Model:Stella-C1	Date:20-Jun-02	No.: MB044001a
-----------------	----------------	----------------

MB Correction

Modified Article: Parts catalog correction		Prepared by: M.Ishihara	
From: Technical Services sec. Service Planning Dept.			
Reason for Modification:	☒ Parts catalog correction	☐ Vendor change	☐ To meet standards ()
	☐ To facilitate assembly	☐ To improve reliability	
	☐ Part standardization	☐ Other

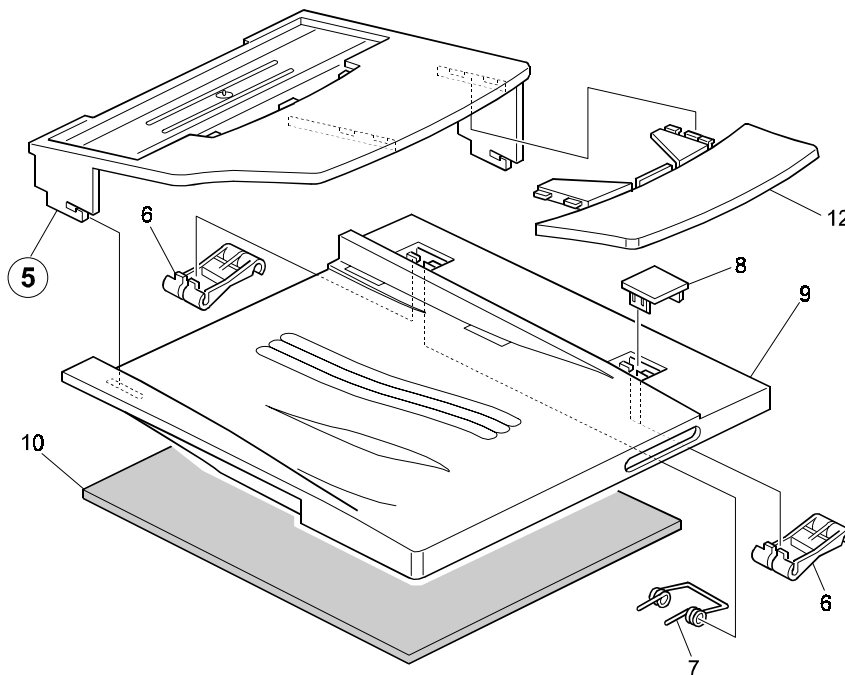
- Please CORRECT the following (pg. 18):
 Incorrect: In the illustration below, index #5 and #9 both point to the Platen Cover.
 Correct: Index #9 is for the Platen Cover, and index #5 is for the Original Table (B0444948).

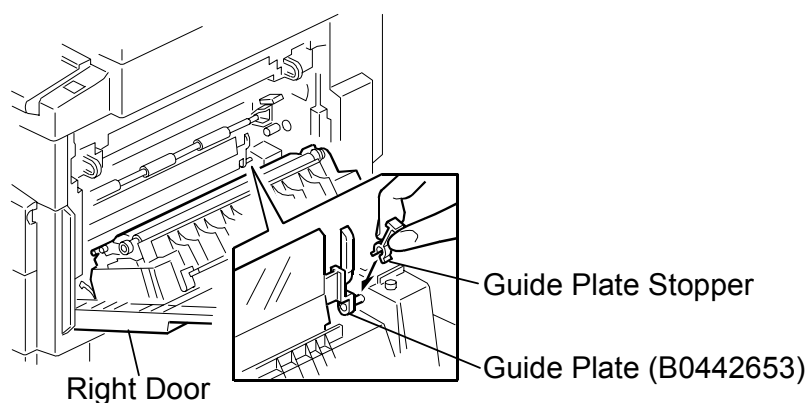
A Stopper has been added to the Guide Plate shaft to ensure the Guide Plate pivot point does not come out of place, which can occur when paper jammed in the transport section is removed from the paper tray side with the right door closed (normally, paper jammed here should be removed after opening the right door).

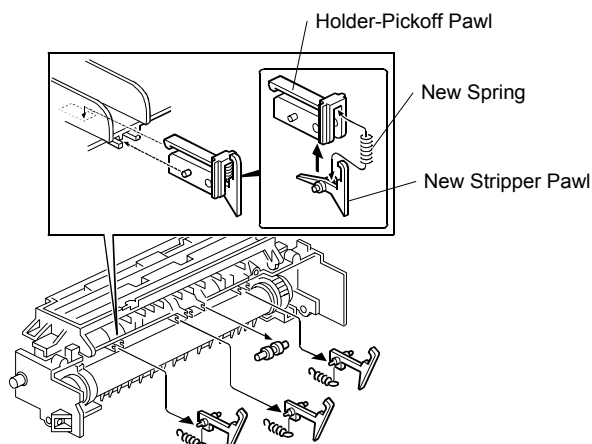
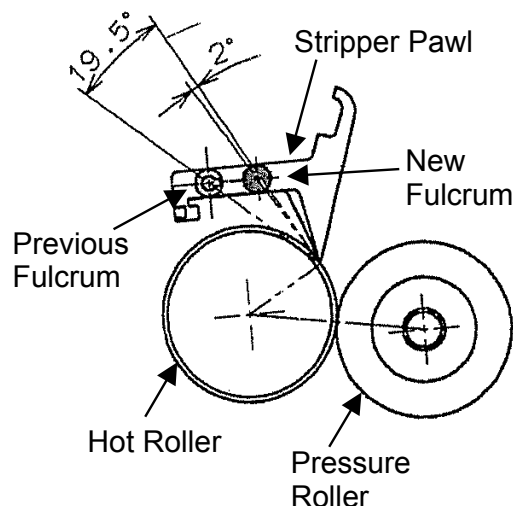
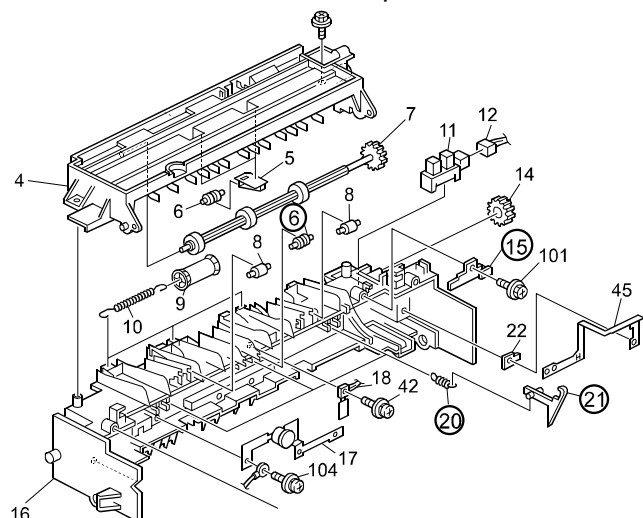
The fulcrum of the Stripper Pawls has been changed as shown below to eliminate squeaking noises coming from the pawls. In addition, pawl holders have been added for attachment to the pawls before installation in the fusing frame (frame remains unchanged).

X/O*: **Interchangeability is X/O as a set.** In addition, whenever replacing the old with the new, be sure to install **all four** new parts above as a set.

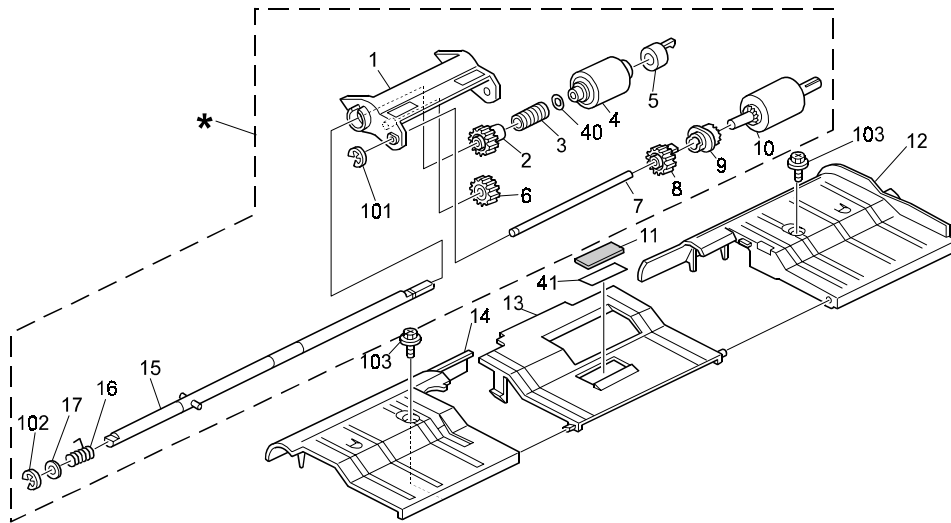
The Original Feed Unit has been registered as a service part to facilitate assembly. This is a "Rank A" PM part, and consists of the parts shown inside the box below.

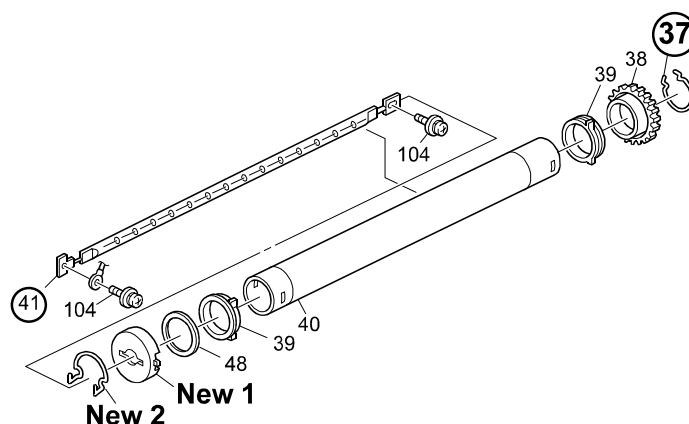
- 1) Fusing lamp filament changed for an even more stable fusing temperature.
- 2) Cap added to the front side of the hot roller (illustration below).
- 3) Front stopper on hot roller changed to accommodate hot roller cap.

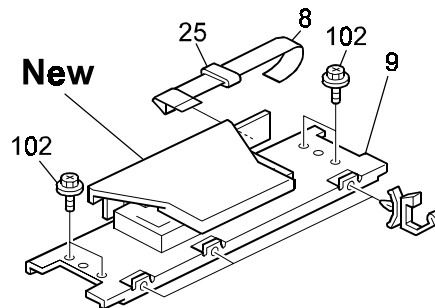
The following part is available as a service part.

<Page 12, 13>

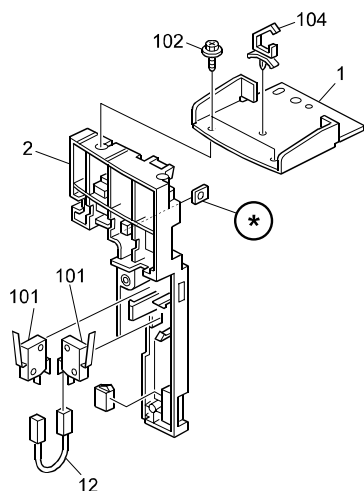
Incorrect part number	Correct part number	Description	Q'ty	Int	Page	Index	Note
-	B0444200	Fusing Plate Nut	2	-	12, 13, 32, 33	31, * (New)	
B0444200	B0444135	Lamp Holder	1-2		34,35	33->22

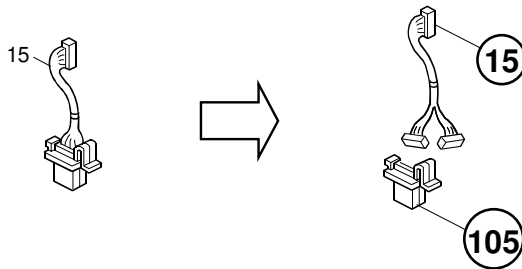
Part number	Description	Q'ty	Int	Page	Index	Note
B0445223	Harness – Paper Feed Table	1		39	15	
11028534	Connector – OR/P17 – 14S - B	1		39	105

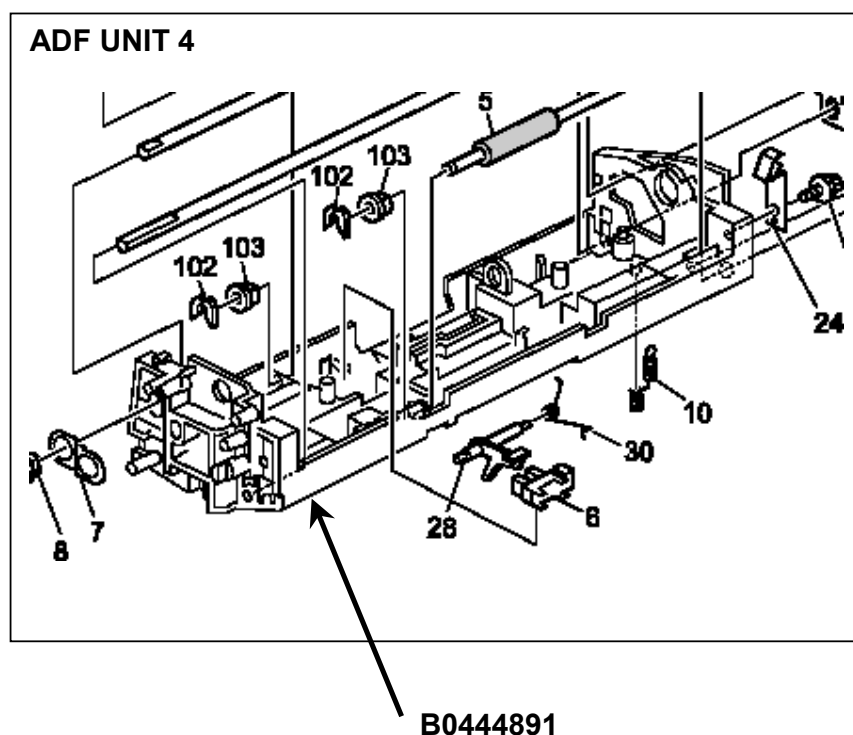
Change: This part was added.

Reason: It was missing from the Parts Catalog.
